**Federal Aviation
Administration**

Aeronautical Charting Forum 14-02 Reston, VA

AERONAUTICAL CHARTING FORUM (ACF)
MEETING 14-02 OCTOBER 28-30, 2014
HOST: PRAGMATICS, INC.
1761 BUISNESS CENTER DRIVE
RESTON, VA 20190

INSTRUMENT PROCEDURES GROUP (IPG) AGENDA

HOLTZ NINE DEPARTURE (RNAV)

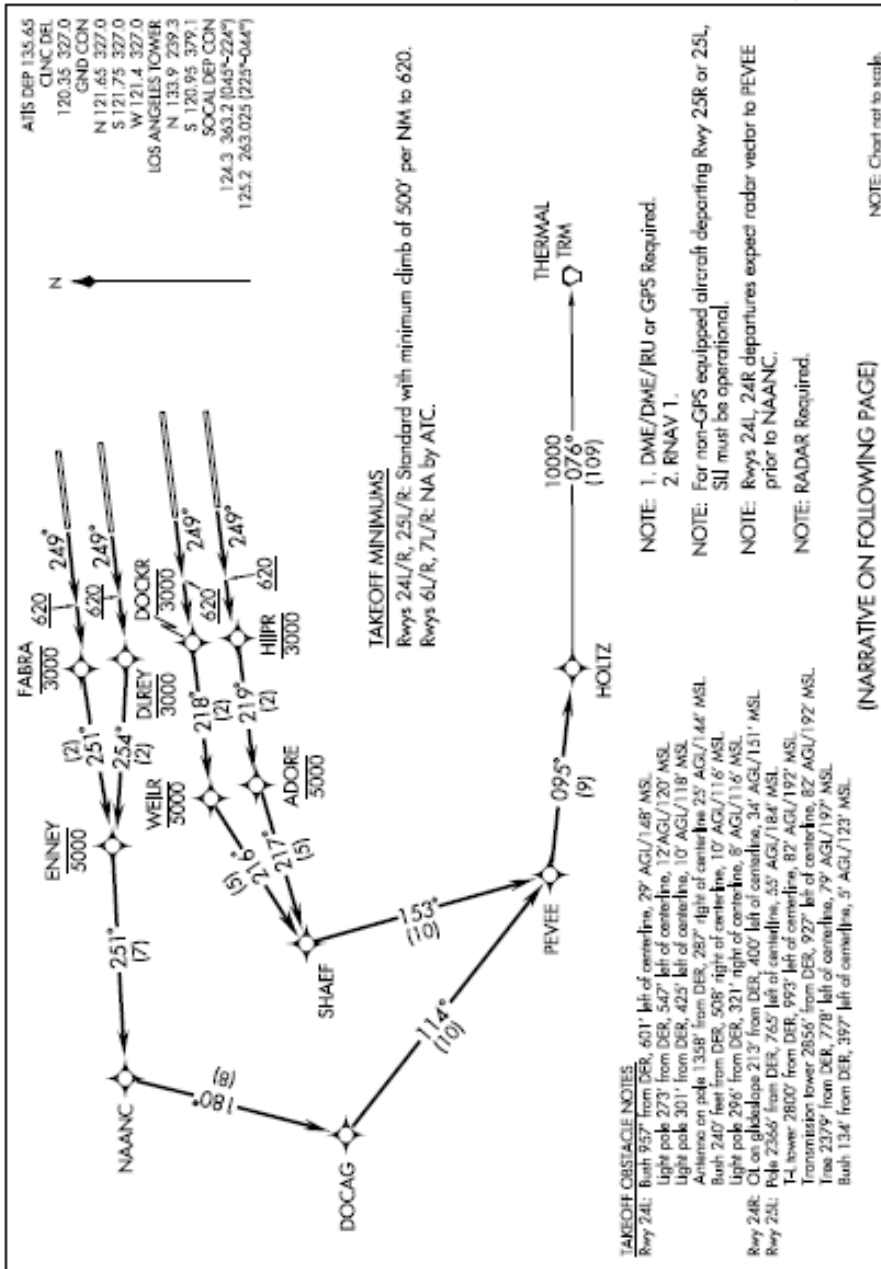
1. Discrepancy of when LNAV engagement altitudes are presented on the plan view of both AeroNav Products and Jeppesen charts.
2. Inconsistency of how the chart planview designates a crossing altitude between charts at different airports of same manufacturer (i.e. AeroNav Products)
3. Inconsistency of how the chart planview designates an engagement altitude between manufacturers (AeroNav versus Jepp).

Examples will be provided as it is the best way to see the breadth of the problem, but in general some SIDs have them and some do not. In most cases they only contribute to chart clutter and no useful purpose (see attached charts). Additionally, they may be charted as “usable altitudes” such as “1800” or may show up as “less usable altitudes” such as “1861”. It is possible that they are charted as “at”, “at or below”, or “at or above”, but really serve no purpose other than to anchor the RNAV leg type. Also, Jepp has added a “climb to” on the planview (consistent with AeroNav products text) that may be confusing pilots that think it is an altitude restriction.

MUDDE ONE DEPARTURE (RNAV)

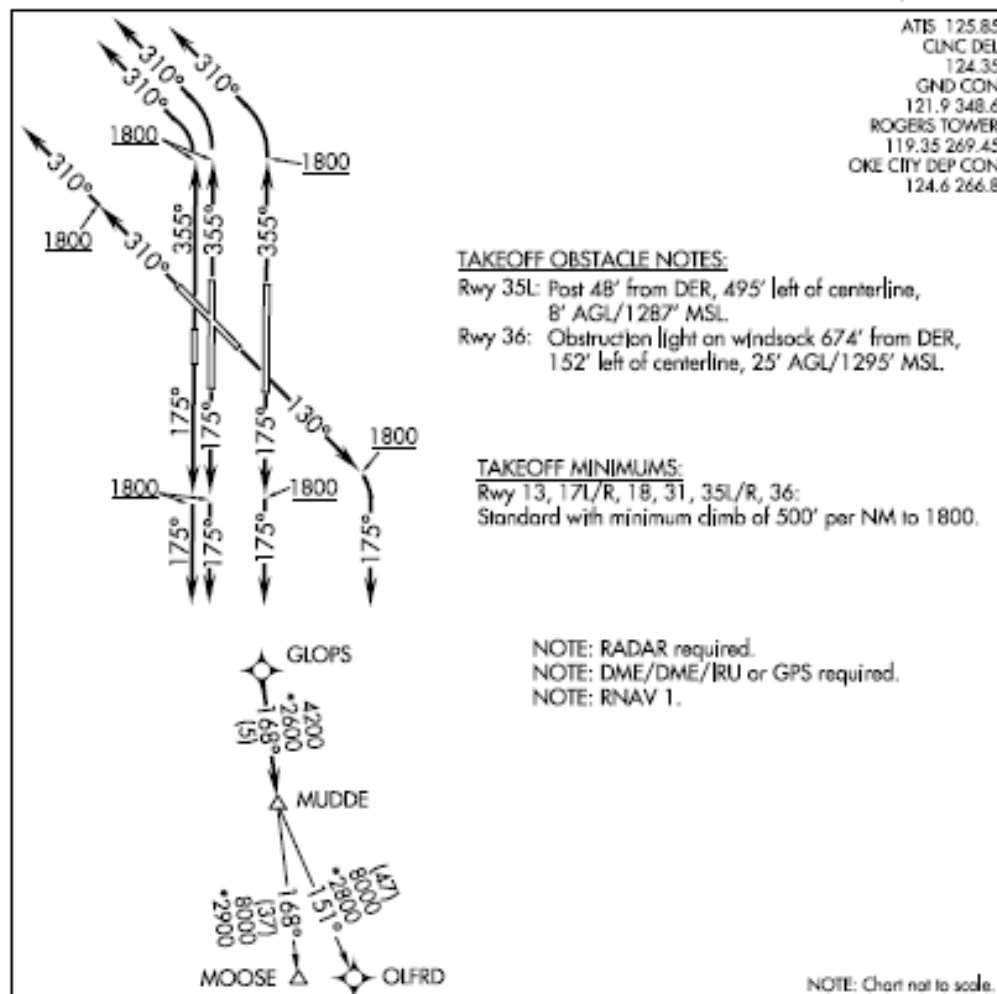
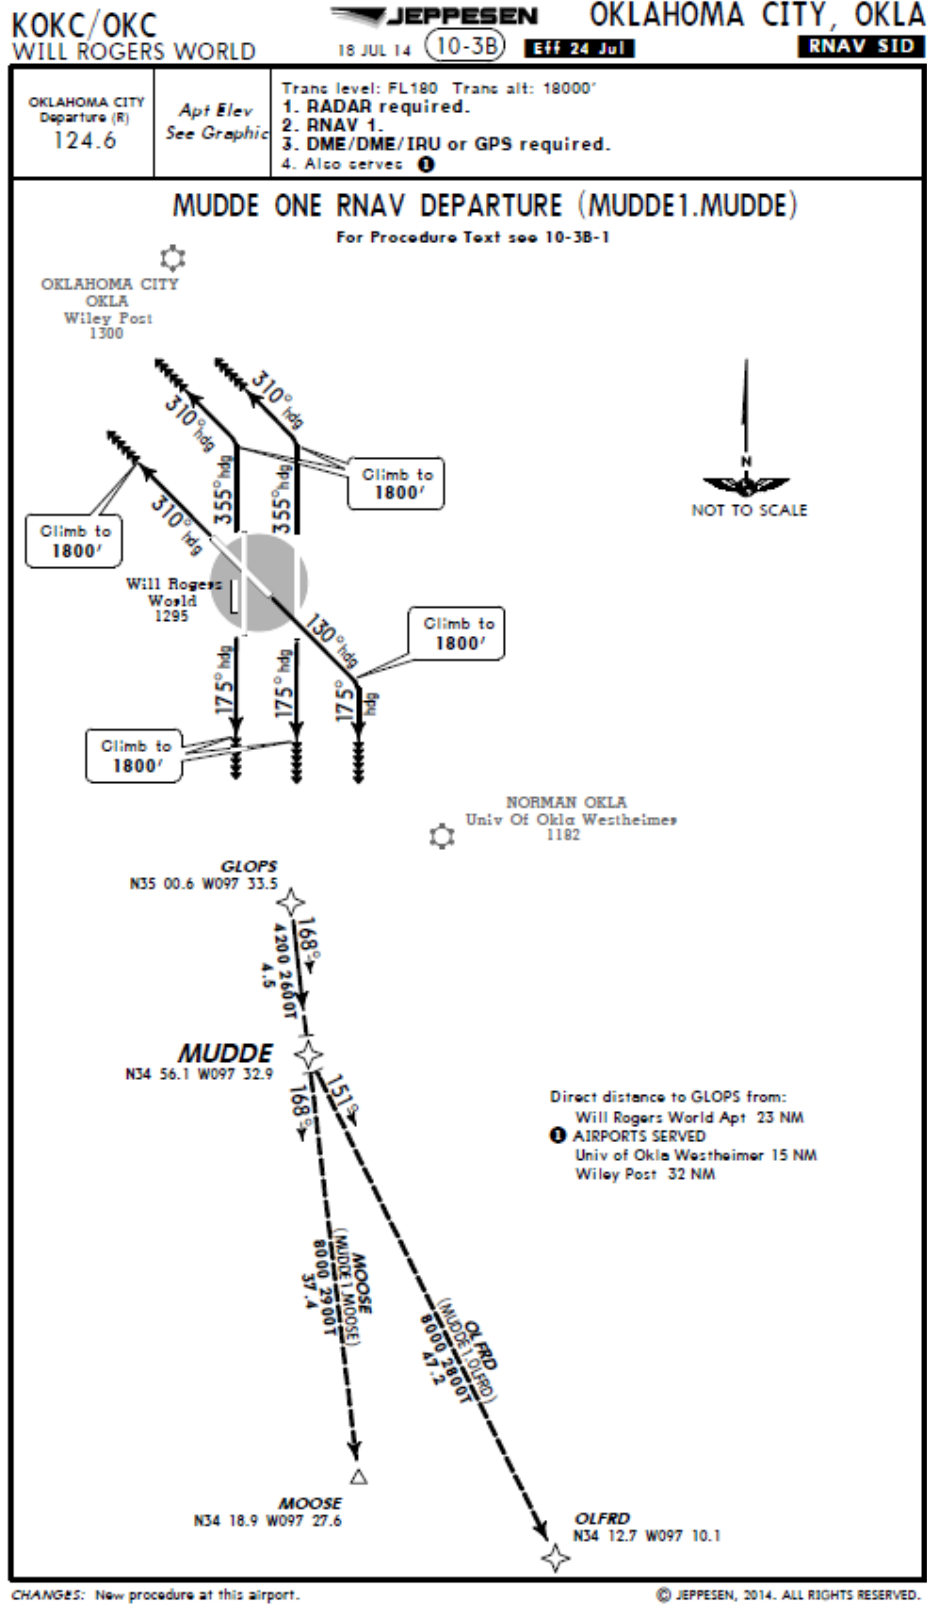
Recommendations: If these are in fact the highest possible altitude that may be assigned for these routes, they should be charted as such with the line over the altitude. On radar vector SID's provide a lost communications procedure if communications are not established.

Figure 1 - Seattle-Tacoma International (SEA 9/24/2014)**Figure 2 - SEA HOT SPOT 3**

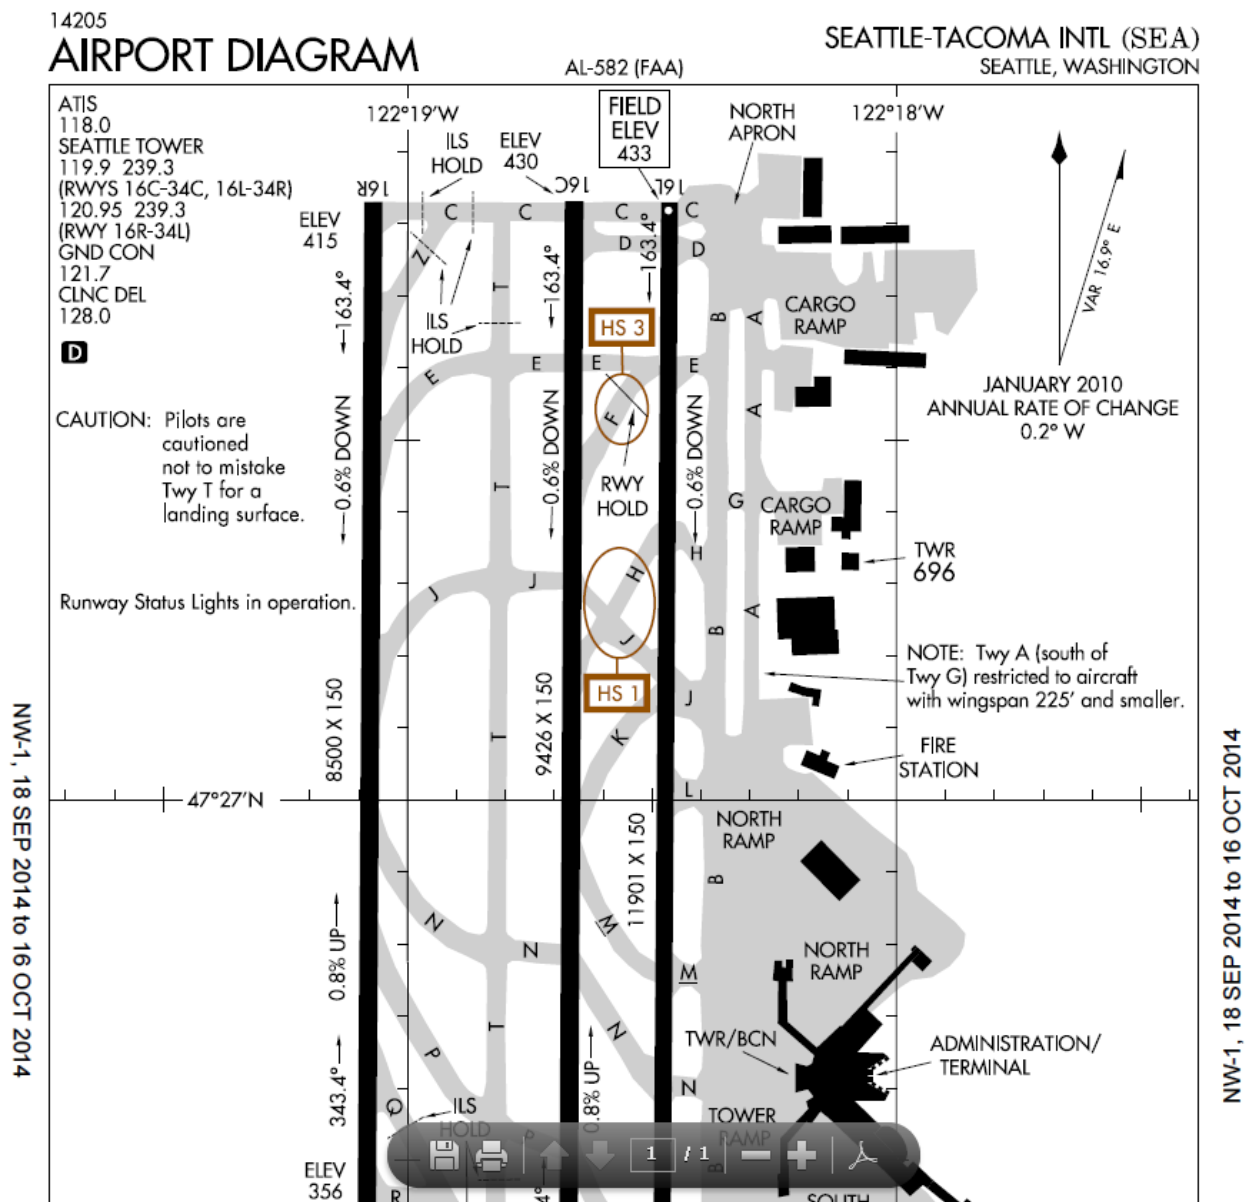
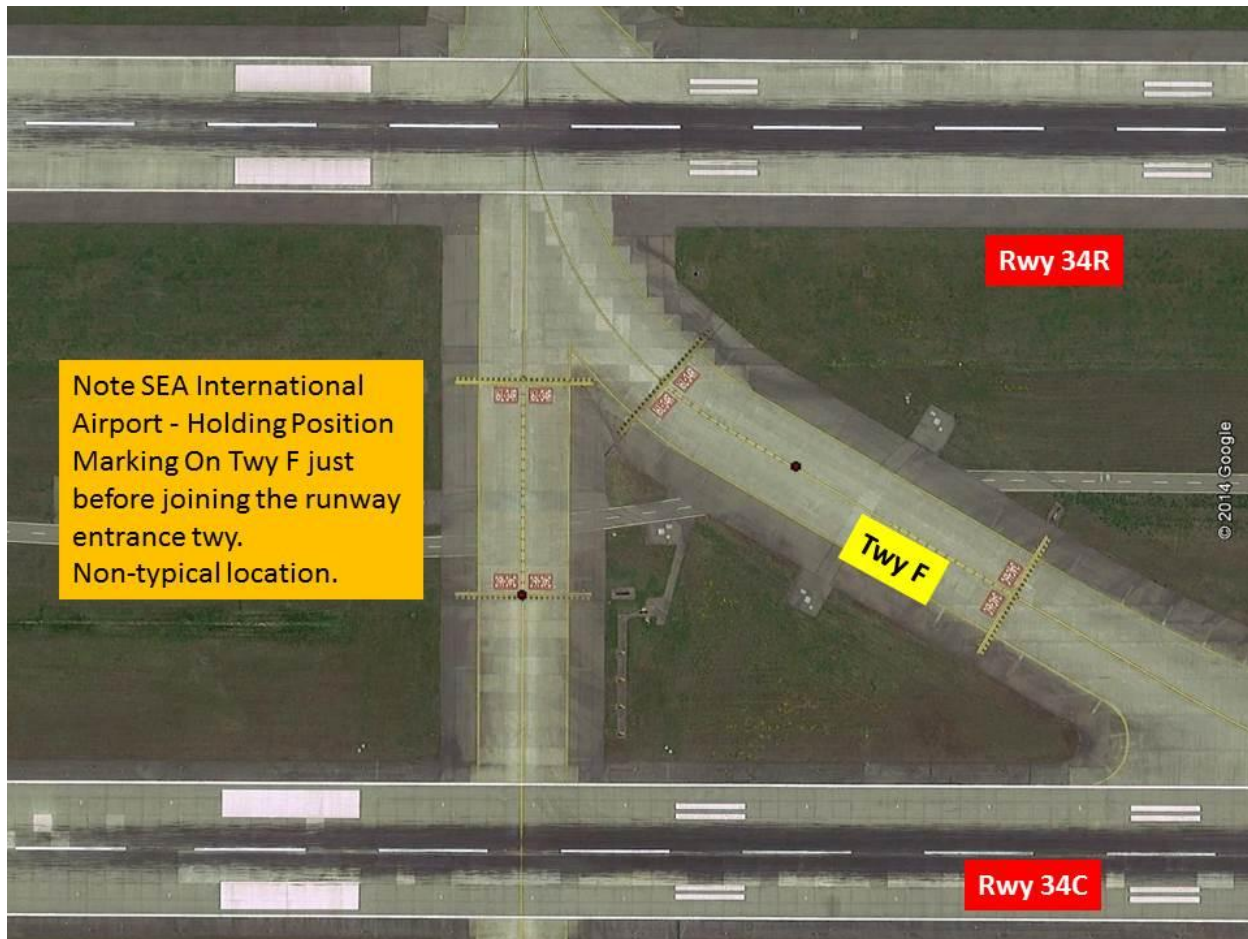
Remove the prohibition against showing non-standard hold lines in conjunction with a Hot Spot that already exists for this purpose. In short, publish both the hot spot AND the hold line.

Comments: The following graphics are provided for references to the above background para.
